**New Jersey Department of
Transportation
Americans with Disabilities Act “ADA”
Regional Facilities Site Inspections**

Status of Repairs

October 2010

NJDOT ADA Regional Facilities Site Inspections

Signage for Goods and Services (ADAAG 4.30)

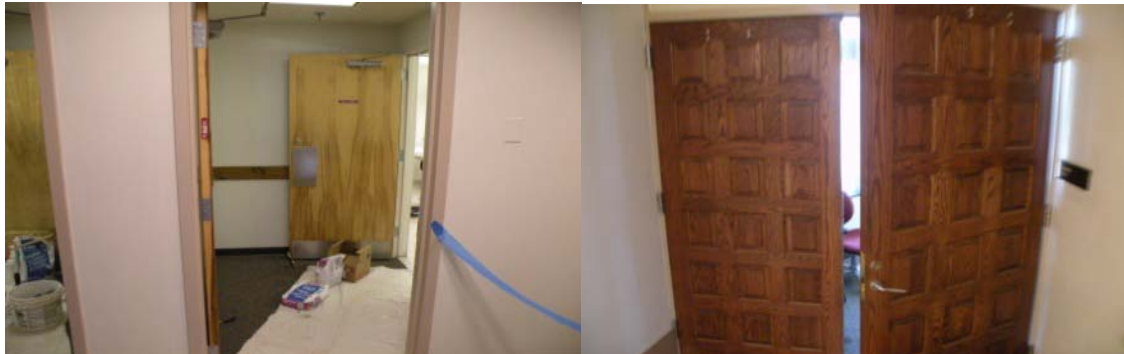
Signage in rest rooms and Meeting Room are not in Braille. Provide signs that have raised letters, Grade II Braille, and that meet all other requirements for permanent room or space signage (See ADAAG 4.1.3(16) and 4.30.)

AFTER: Signs installed that have raised letters, Grade II Braille, and that meet all other requirements for permanent room or space signage. Work completed 9/9/10.
